**PLANS AND DOCUMENTS  
referred to in the PDA  
DEVELOPMENT APPROVAL**

**Approval no:** DEV2019/1010

**PROPOSED MIXED USE DEVELOPMENT  
AT MUNDOO BOULEVARD, MAROOCHYDORE  
FOR HABITAT DEVELOPMENT GROUP PTY LTD  
BASEMENT WATERPROOFING BELOW DEFINED FLOOD LEVEL**

BASEMENT WALL SECTION - WATERPROOFING APPROACH

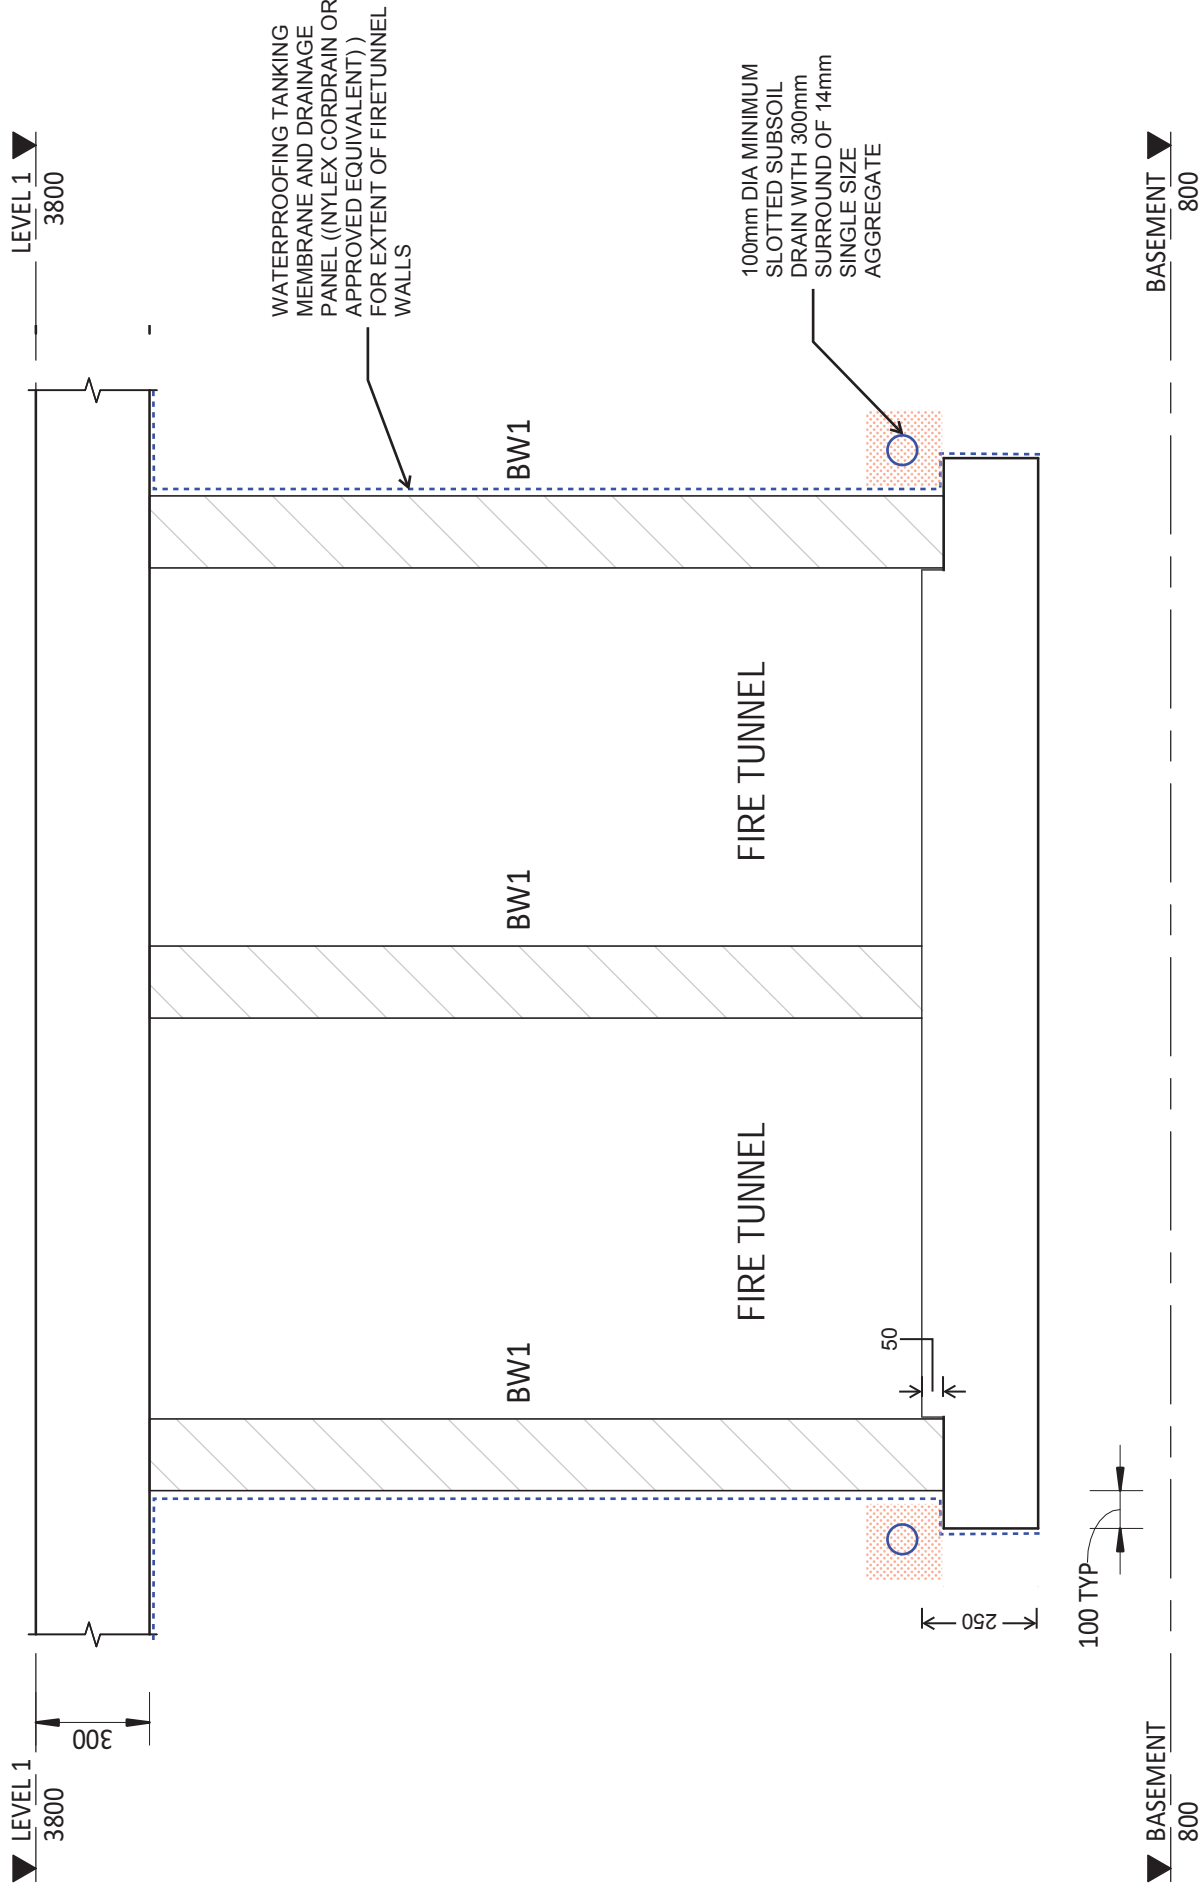
The attached waterproofing details provided by the structural engineer (Projex Partners – Jeffrey Roulston) are deemed adequate and suitable to maintain a waterproof basement.
